UNITED STATES PATENT AND TRADEMARK OFFICE

10/613,605

Office Action Summary	Application No. 10/613,605	Applicant(s) DEROGATIS ET AL.	
	Examiner Ernesto Garcia	Art Unit 3679

DETAILED ACTION

Rapata, 3,539,234

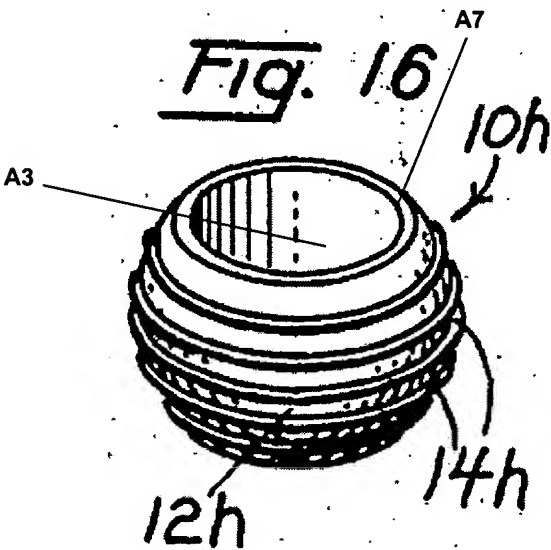
Claims 1,7, 8, 11, 13, 49-52, 54, 56-61, and 63 are rejected under 35 U.S.C. 102(b) as being anticipated by Rapata, 3,539,234 (see marked-up attachment).

Regarding claim 1, Rapata discloses, in Figure 16, a plug fastener **10d** comprising a first engaging portion **A1** and a second engaging portion **A2**. The first engaging portion **A1** has first ridges **14d**. The second engaging portion **A2** has second ridges **14d**. The first ridges **14d** are slanted with respect to the second ridges **14d**. An aperture **A3** extends through the plug fastener. The first ridges **14d** and the second ridges **14d** are concentric with respect to the aperture **A3**.

Regarding claim 7, at least one of the first ridges **A1** or the second ridges **A3** comprises an angled top surface **A5**. The angled top surface provides the slant of the first ridges **14d** or the second ridges **14d**.

Regarding claim 57, Rapata discloses in Figure 16, a substantially plug fastener **10h** comprising an aperture **A3**, a first hemisphere **A1**, and a second hemisphere **A2**. The aperture **A3** extends through the plug fastener and has a first opening **A7** and a second opening (below opposite to **A7**). The first hemisphere **A1** has first ridges **14d** concentric and orthogonal with respect to the aperture **A3**. The first hemisphere **A1** includes the first opening **A7**. The second hemisphere **A2** has second ridges **14h** concentric and orthogonal with respect to the aperture **A3**. The second hemisphere **A2** includes the second opening. Ends of the first ridges **14h** and the second ridges **14h** are tapered respectively from the first opening and the second opening towards a maximum diameter of the fastener **10h** (note that the ridges are curved such that half of the curved is tapered towards the maximum diameter).

Waldron, 3,438,659

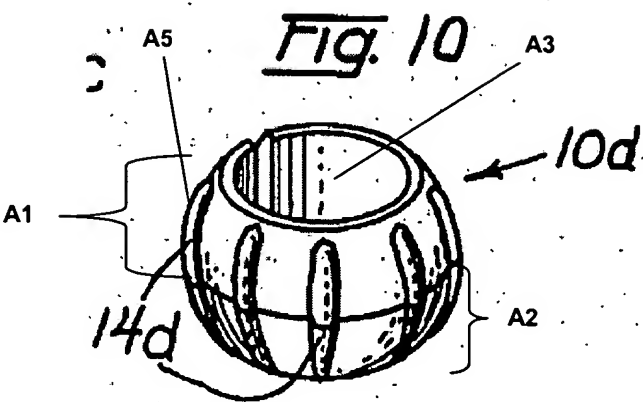
Claims 1, 7, 8, 11, 13, 49, and 50 are rejected under 35 U.S.C. 102(b) as being anticipated by Waldron, 3,438,659.

Regarding claim 1, Waldron discloses, in Figure 14, a plug fastener **42** comprising a first engaging portion and a second engaging portion. The first engaging portion has first ridges **47**. The second engaging portion has second ridges **47**. The first ridges **47** are slanted with respect to the second ridges **47**. An aperture **A3** (see marked-up attachment) extends through the plug fastener **42**. The first ridges **47** and the second ridges **47** are concentric with respect to the aperture **A3**.

Regarding claim 7, at least one of the first ridges **47** or the second ridges **47** comprises an angled top surface **A5**. The angled top surface provides the slant of the first ridges or the second ridges.

Harder, 6,932,329

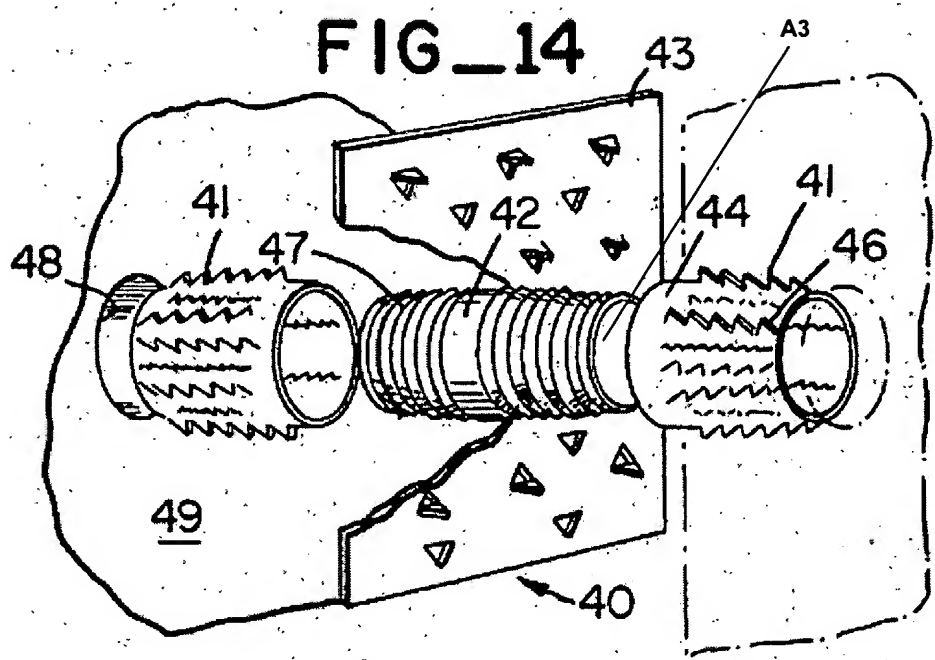
Claims 1, 53, 54, 55, 57, 62-64 are rejected under 35 U.S.C. 103(a) as being unpatentable over Harder, 6,932,329, in view of Astl, 5,131,783.

Regarding claim 1, Harder discloses, in Figures 7 and 8, a plug fastener **23** comprising a first engaging portion **A1** and a second engaging portion **A2**. The first engaging portion **A1** has first ridges **37,38**. The second engaging portion **A2** has second ridges **39,40**. An aperture **41** extends through the plug fastener **23**. The first ridges **37,38** and the second ridges **39,40** are concentric with respect to the aperture **41**. However, Rapata fails to disclose the first ridges **37,38** slanted with respect to the second ridges **39,40**. Astl teaches, in Figure 5, different types of ridges for being more rigid due to greater supporting area (col. 3, lines 61-68). In particular, the fourth embodiment provides the first ridges being slanted with respect to the second ridges when the ridges of Harder are substituted for those of Astl. Therefore, as taught by Astl, it would have been obvious to one of ordinary skill in the art at the time the invention was made to replace the ridges of Harder with any known ridge design so that the

Regarding claim 53, the aperture **41** further comprises at least one countersink **42** formed at one end of the aperture **41**.

Regarding claim 57, Harder discloses in Figures 6 and 7, a substantially plug fastener **23** comprising an aperture **41**, a first hemisphere **A1**, and a second hemisphere **A2**. The aperture **41** extends through the plug fastener and has a first opening **A7** and a second opening **A8**. The first hemisphere **A1** has first ridges **37,38** concentric and orthogonal with respect to the aperture **41**. The first hemisphere **A1** includes the first opening **A7**. The second hemisphere **A2** has second ridges **39,40** concentric and orthogonal with respect to the aperture **41**. The second hemisphere **A2** includes the second opening **A8**. However, Harder fails to disclose ends of the first ridges **37,38** and the second ridges **39,40** being tapered respectively from the first opening and the second opening towards a maximum diameter of the fastener **23**. Astl teaches, in Figure 5, different types of ridges for being more rigid due to greater
